May 28, 2008

Re: Responses to Comments on the 95% Design  
Herrick Hollow Creek Restoration  
Richardson Hill Landfill Site

**Comments from USEPA, USFWS and NYSDEC  
Contained in USEPA's Letter Dated April 30, 2008**

Sheet Number  
11

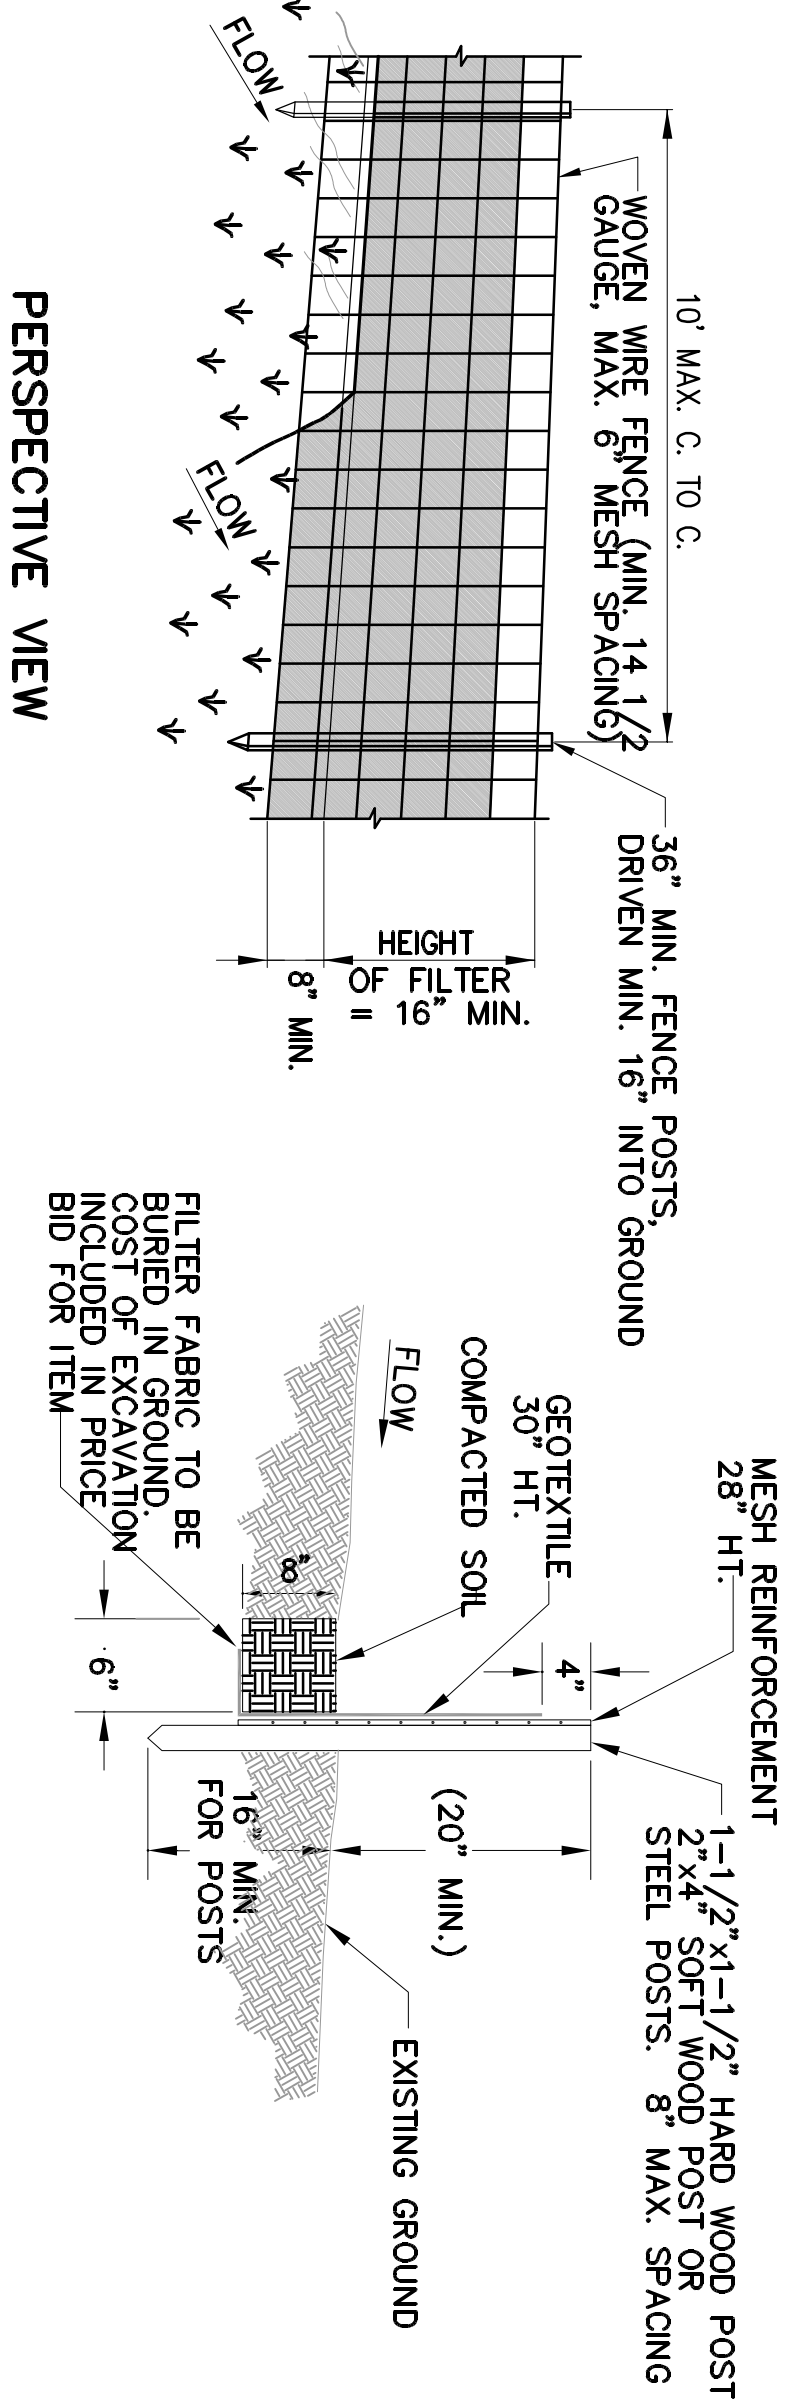
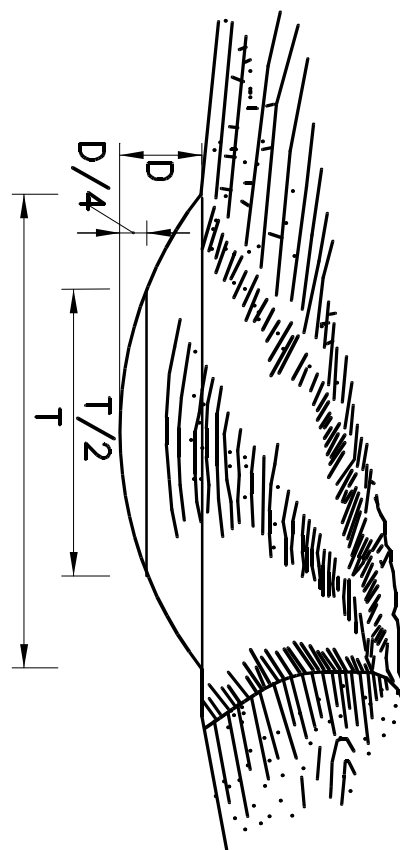
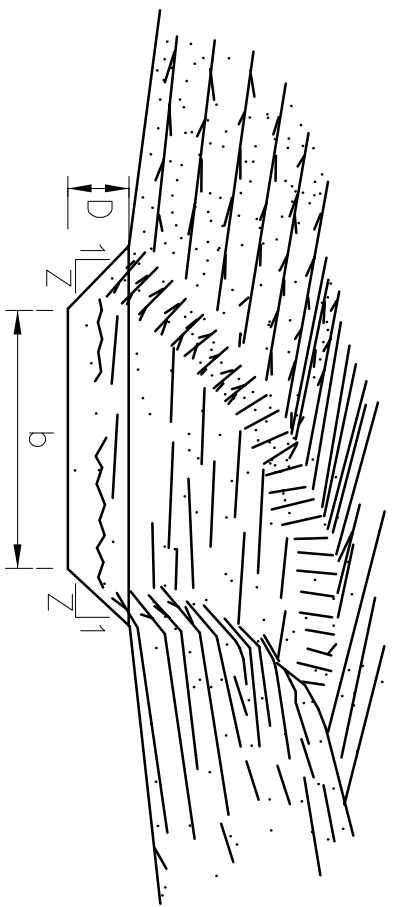
## Sheet 11

1. Fueling should always be conducted outside of stream and wetland corridors.

2. All activities should produce NO visible contrast rather than no “substantial” visible contrast.

3. Is the ERNMX-120 composed of native species? If not, please choose a seed mix that is.

4. Will compaction of grassed swale materials interfere with establishment of vegetative cover. If so, perhaps less compaction or post-compaction roughening of the surface should be employed.

*Response* – The note on this sheet has been modified to prohibit the fueling of equipment within the stream and wetland corridors.

*Response* – This change has been made.

*Response* – The ERNMX-120 mix includes many native species

*Response* – The note on this detail has been changed to specify post compaction roughening of the seedbed to improve root development.
